Form 3160-5 (June 2015)

1. Type of Well	<u></u>	8. Well Name and No. TOMB RAIDER 1-12 FED 234H				
② Oil Well ☐ Gas Well ☐ Oth 2. Name of Operator	9. API Well No.					
DEVON ÉNERGY PRODUCT		30-015-44593-00-X1				
3a. Address 333 WEST SHERIDAN AVEN OKLAHOMA, OK 73102	3b. Phone No. (include area code) Ph: 575-748-1819			10. Field and Pool or Exploratory Area LIVINGSTON RIDGE

FLOWLINE PLAT

FOUR-8" POLY FLOWLINES AND ONE-8" GAS LIFT LINE BURIED IN THE SAME TRENCH FROM TOMB RAIDER 1-12 FEDERAL COM 718H, 528H, 334H, & 234H TO TODD-APACHE 1-1 CTB 3

SHEET: 1-4

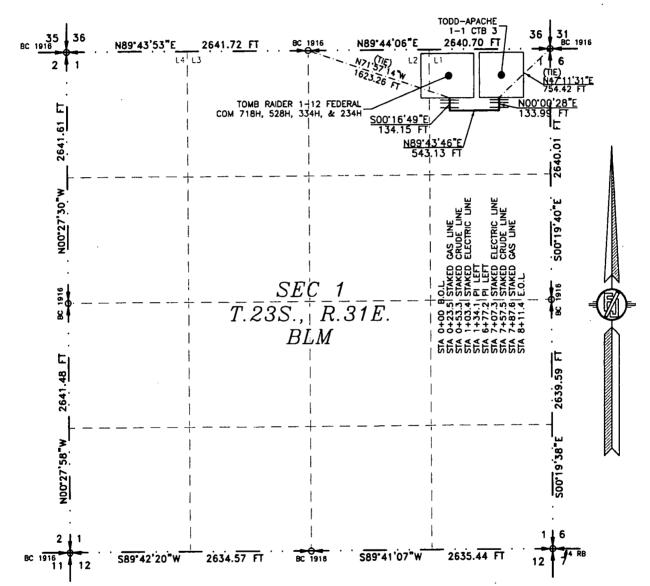
13. Describe Proposed or Completed Op	☐ Convert to Injection			☐ Water I		
If the proposal is to deepen direction: Attach the Bond under which the wo following completion of the involved testing has been completed. Final Al determined that the site is ready for f Devon is requesting approval permitted to 8" (eight inch). Route will not change, route w	rk will be performed or provid l operations. If the operation ro bandonment Notices must be fi inal inspection. to change the flowline ar	e the Bond No. on esults in a multiple led only after all rand gas lift line f	file with BLM/BIA completion or reco requirements, includ	Required submpletion in a ing reclamation chipself.	bsequent reports must b new interval, a Form 31 n. have been completed	e filed within 30 days 60-4 must be filed once
718H and remains in approve	d flow line corridor for To	dd Apache Mi	OP1.	20411, 00411	, 02017 0110	RECEIVED
